Access Compliance Report

Public Rights-of-Way

Intersection ID: 12972	Main Street: HAMORTON_PL	Cross Street: THOMAS_AV	Location: NE
ADA ID: 714EC5CFE49F	Ramp Type: PerpDiag	Initial Pass/Fail: Fail	Overall Compliance: No
		Severity Score: 22.5

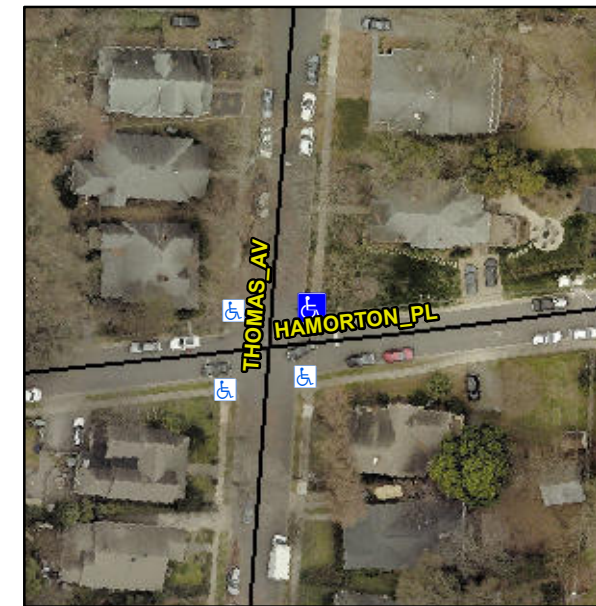
Not Found, R304.5.1, R304.2.2, R304.5.3

Compliance	Description	Data	Compliance	Description	Data
N/A	Ramp Length (in)	42.5	No	Ramp Slope (%)	11.4
No	Ramp Width (in)	39.0	No	Ramp XSlope (%)	2.3
N/A	Flare Type LT	N/A	N/A	Flare Type RT	N/A
N/A	Flare Slope LT (%)	N/A	N/A	Flare Slope RT (%)	N/A
N/A	Flare Traversable LT?	N/A	N/A	Flare Traversable RT?	N/A
N/A	Landing Length (in)	N/A	N/A	DWS Provided?	N/A
N/A	Landing Width (in)	N/A	N/A	DWS Contrast?	N/A
N/A	Landing Slope (%)	N/A	N/A	DWS Length (in)	N/A
N/A	Landing X Slope (%)	N/A	N/A	DWS Full Width?	N/A
N/A	Landing Curb? (Y/N)	N/A	N/A	DWS Offset (in)	N/A
N/A	Shared Landing?	N/A			
N/A	Gutter Ponding?	Yes	N/A	Gutter Slope (%)	N/A
N/A	Gutter Lip Ht (in)	N/A	N/A	Gutter X Slope (%)	N/A
N/A	Painted X Walk1?	No	N/A	Painted X Walk2?	No
	X Walk 1 Direction	To W		X Walk 2 Direction	To S
N/A	X Walk 1 Width (in)	N/A	N/A	X Walk 2 Width (in)	N/A
	X Walk 1 Slope (%)	2.6		X Walk 2 Slope (%)	0.6
	X Walk 1 X Slope (%)	0.8		X Walk 2 X Slope (%)	1.6

Remove & Replace Curb Ramp With Two New Directional Ramps or Equivalent.
